ALERT SERVICE BULLETIN

Service Bulletin No.: DA20-27-04, Rev. 0

Title: Rudder Pedal Adjust Cable

2. Effectivity: All DA20 Katana Aircraft

FIGURE 1
HARDWARE

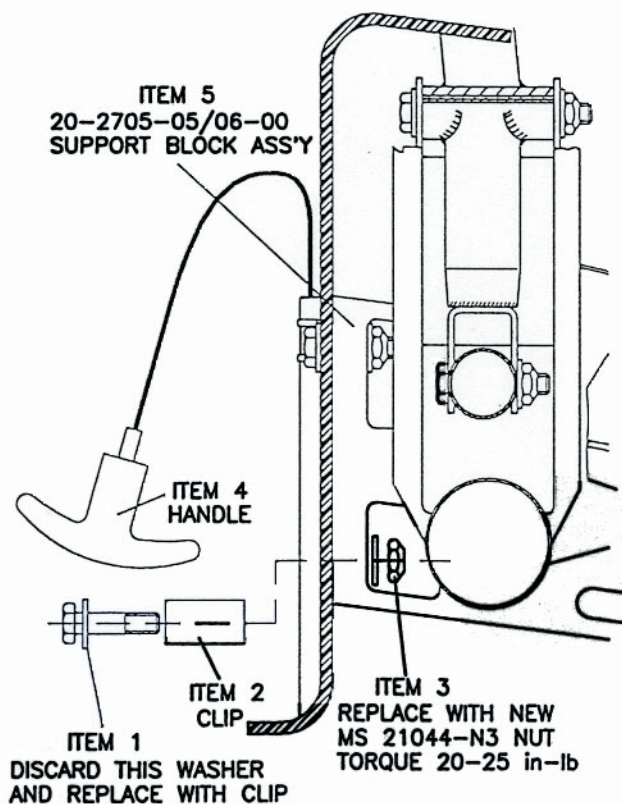
3. General: There is the possibility that, with the pedals adjusted towards the aft position, the pedal adjust 'T'-handle might interfere with the control stick during and following negative 'g' manoeuvres. This bulletin addresses the installation of a retainer for the 'T'-handle.

- 10.1 Remove seat cushion, control stick boot and seat pan to gain access to lower nut (Fig. 1, Item 3) which holds the support block assembly (Fig. 1, Item 5) in place. Remove lower bolt (Fig. 1, Item 1), discard the washer under the head of the bolt and insert the bolt through the retaining clip (Fig. 1, Item 2) and reinstall through support block assembly. Install new nut (Fig. 1, Item 3) and associated washer. Be sure that there is between 1 and 3 threads of the bolt exposed beyond the nut. Rudder pedal adjust handle (Fig. 1, Item 4) when not in use, is to be stowed as shown in Fig. 2.
- 10.4 Inspect for foreign objects and reinstall seat pan, control stick boot and seat cushion.
